Gate Burton Energy Park

EN010131

8.10 Access Updates and Cumulative Impact Assessment
August 2023

This Technical Note describes the process undertaken to minimise environmental impacts associated with accesses since submission of the DCO application and details the changes that have been made to further reduce impacts. It has been prepared for submission at Deadline 2 in the Examination (8 August 2023).

Figure 38: Cottam Road North Access Junction Layout

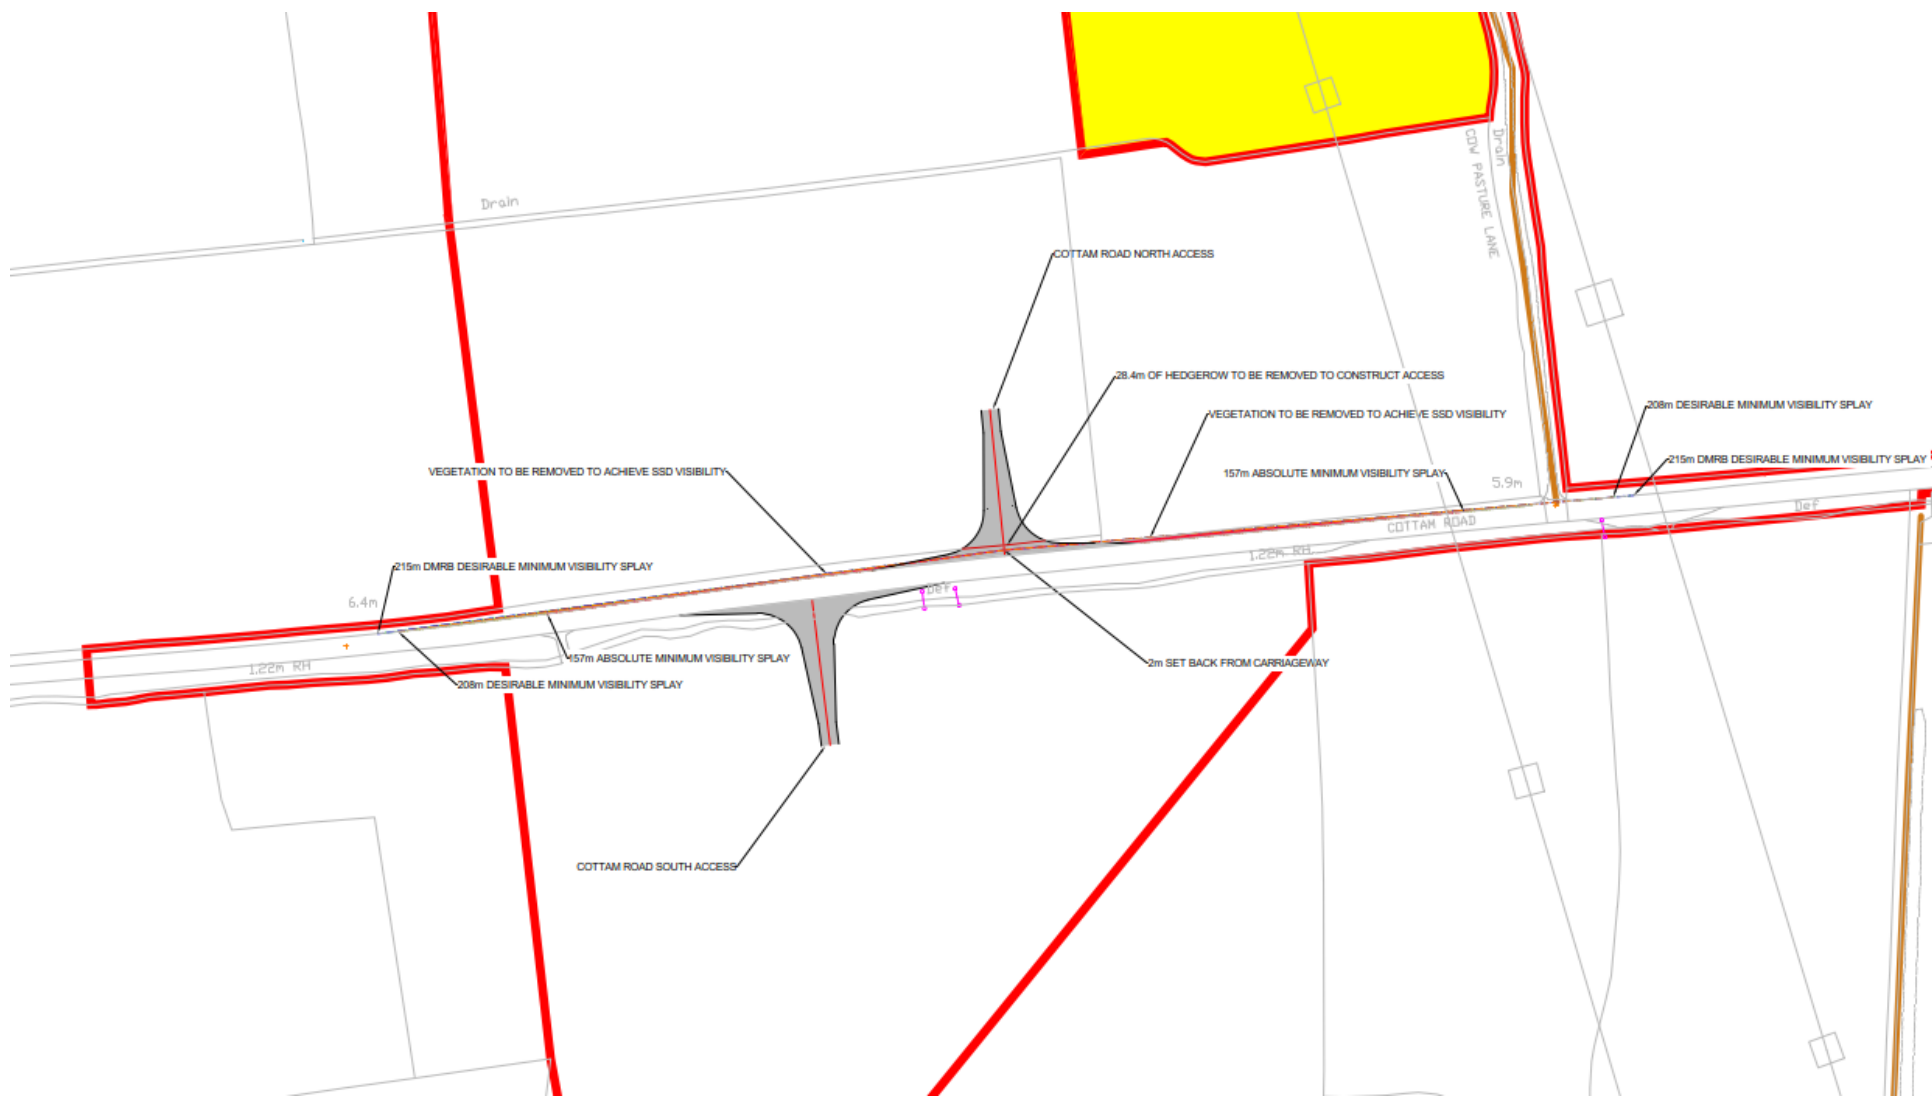
- 12.1.5 The proposed access junction has been designed in accordance with DMRB CD123 Rev 2.1.0. The proposed layout is as shown in [Figure 38](#). Visibility proposed within the DCO layouts showed visibility splays in accordance with DMRB CD109 Rev 1 Table 2.10 desirable minimum SSD. With a posted speed of 60mph for this section of highway, a design speed of 100kph was adopted, giving a visibility requirement of 215m for SSD.

12.1.12 Access drawing 60664324-HGN-DR-CH-0013 presented in the Framework Construction Traffic Management Plan **[APP-167/3.3]** has therefore been updated to reflect the revised visibility requirement of 208m and issued as part of the Applicant's Deadline 2 submission.

Figure 42: Cottam Road South Access Junction Layout

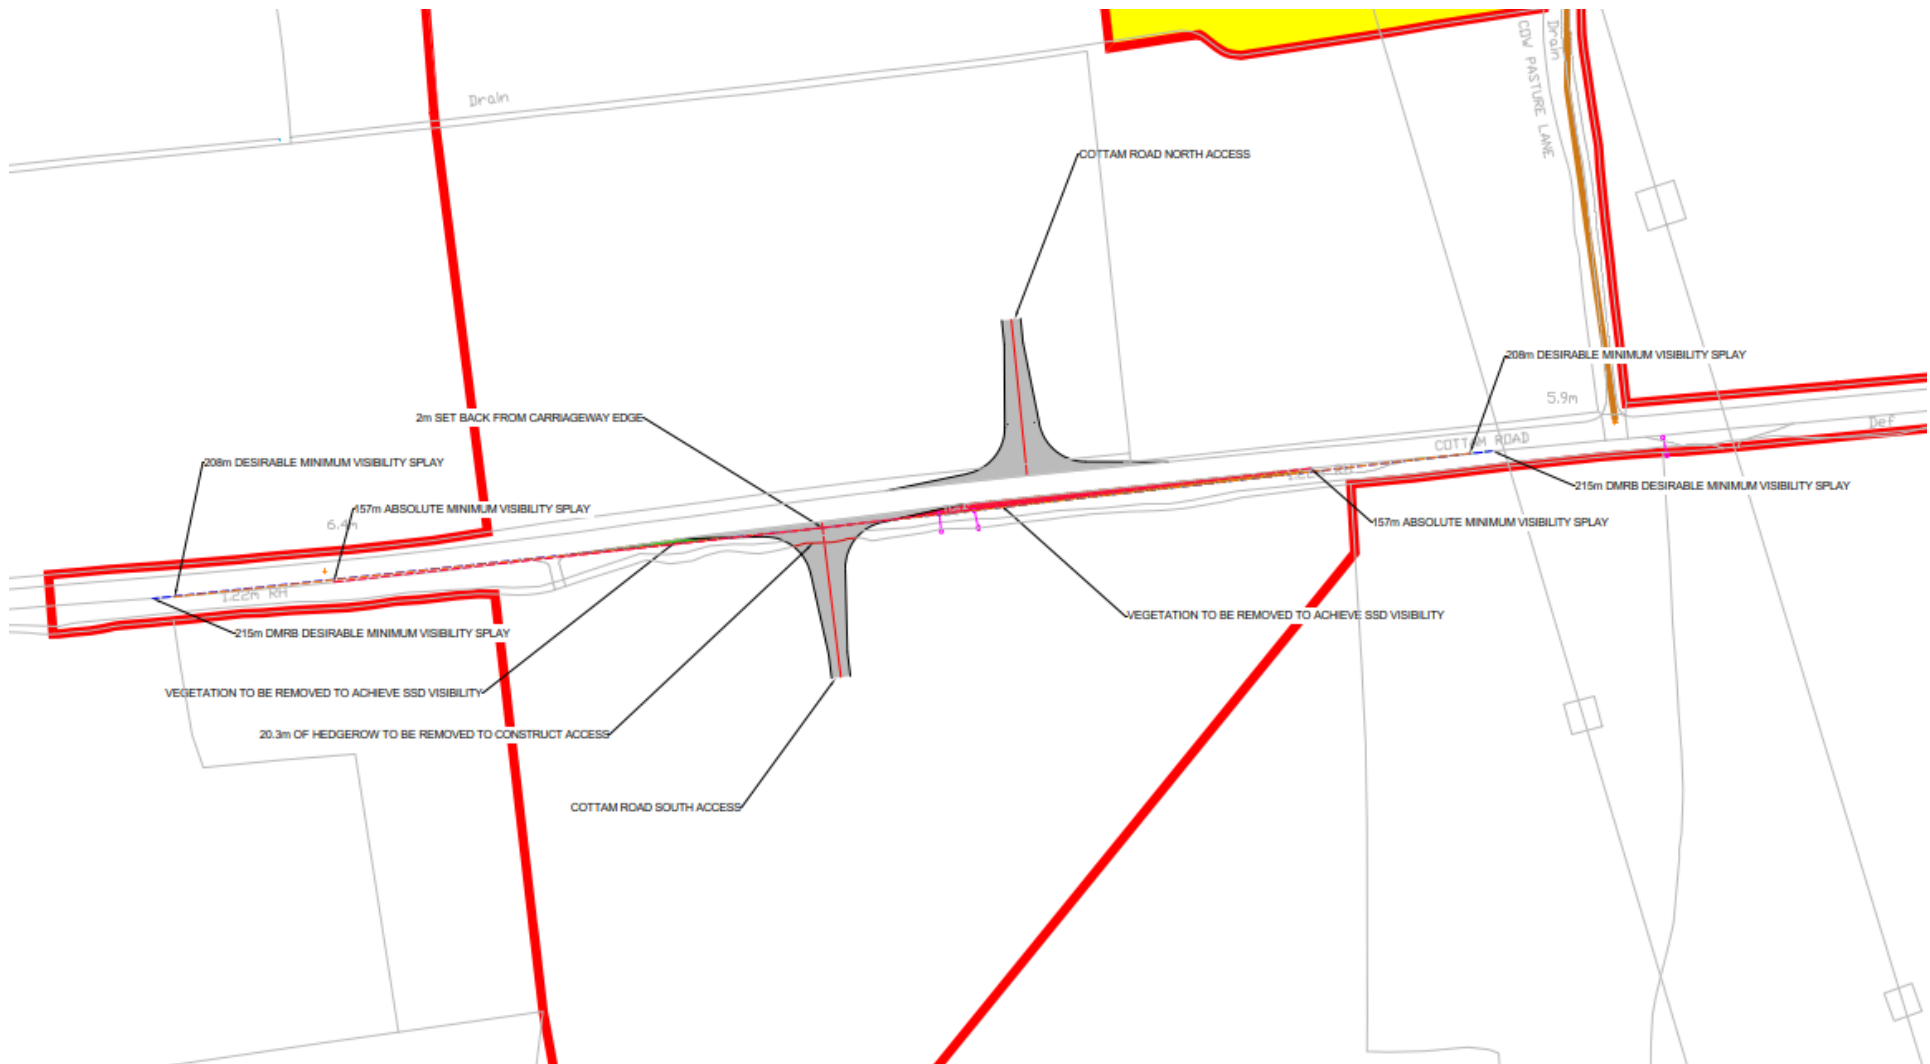
- 13.1.5 The proposed access junction has been designed in accordance with DMRB CD123 Rev 2.1.0. The proposed layout is as shown in [Figure 42](#). Visibility proposed within the DCO layouts showed visibility splays in accordance with DMRB CD109 Rev 1 Table 2.10 desirable minimum SSD. With a posted speed of 60mph for this section of highway, a design speed of 100kph was adopted, giving a visibility requirement of 215m for SSD.

13.1.13 Access drawing 60664324-HGN-DR-CH-0014 presented in the Framework Construction Traffic Management Plan **[APP-167/3.3]** has therefore been

Figure 43 Cottam Road South Access Commonality Review

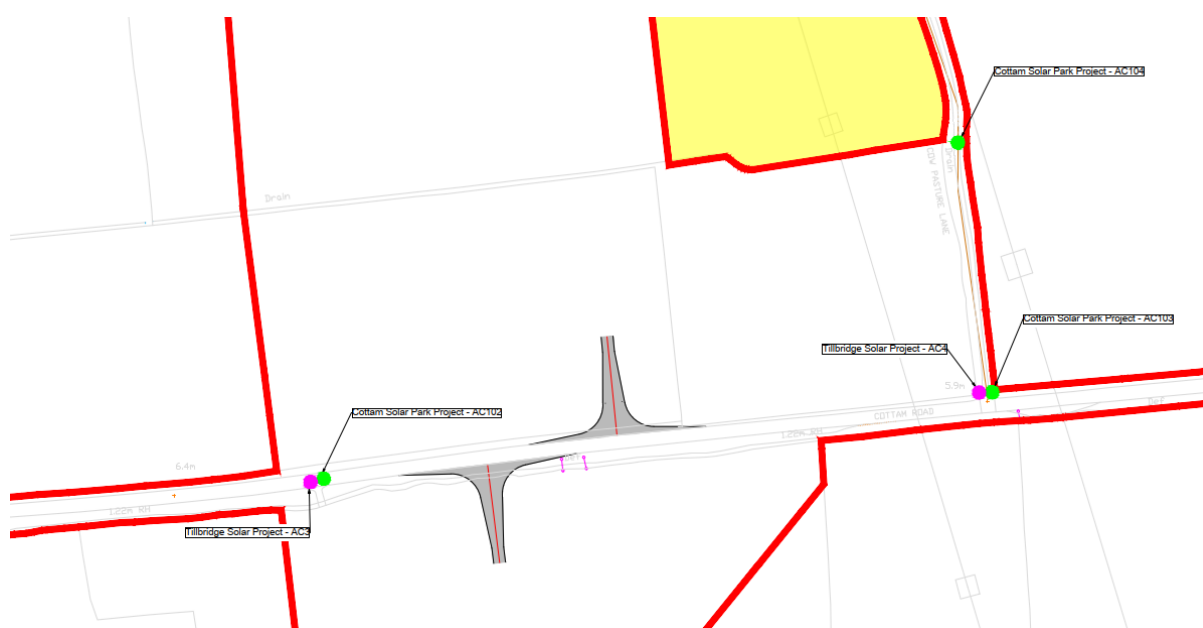
13.1.17 Both Tillbridge and Cottam Solar Park propose to utilise an existing field access point denoted as point 15/01 on Sheet 15 of the Streets, Rights of Way and Access Plans **[APP-210/5.3]** which differs to the strategy proposed by the Applicant. The Applicant has therefore assessed the impact of relocating the current access proposal to align and therefore reduce the cumulate impact.

Figure 44 Cottam Road South Alternative Access Location Sketch

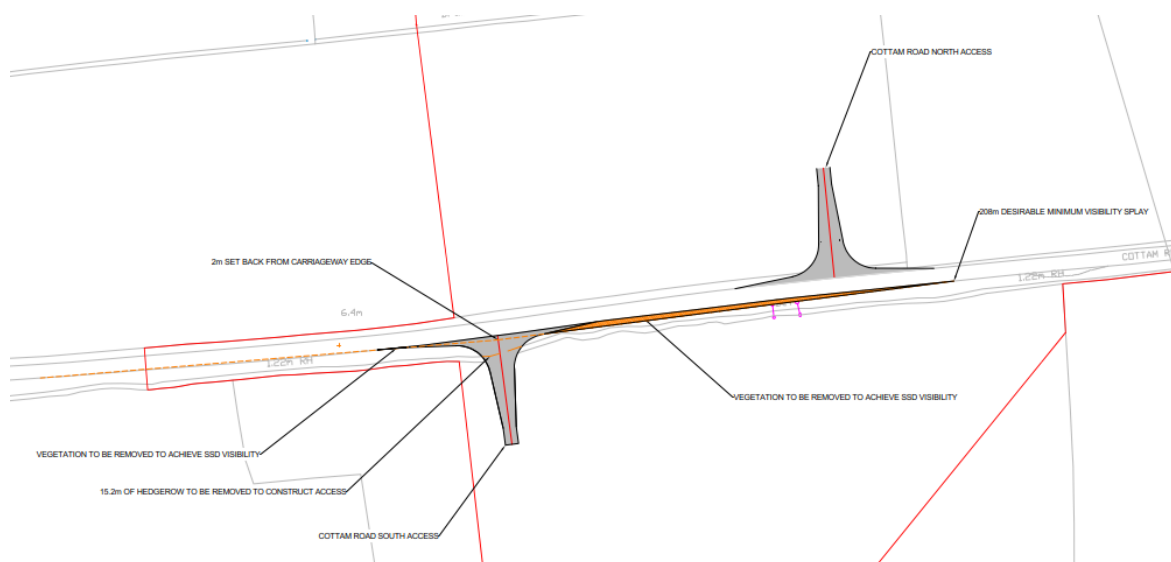
13.1.19 The location of the revised access proposal is provided in Appendix E, with an excerpt provided below in Figure 44.

13.1.20 Access drawing 60664324-HGN-DR-CH-0014 presented in the Framework Construction Traffic Management Plan [APP-167/3.3] will therefore be updated to reflect both the visibility requirement of 208m and the relocation of the access to reduce the overall cumulative impact and has been issued as part of the Applicant's Deadline 2 submission.
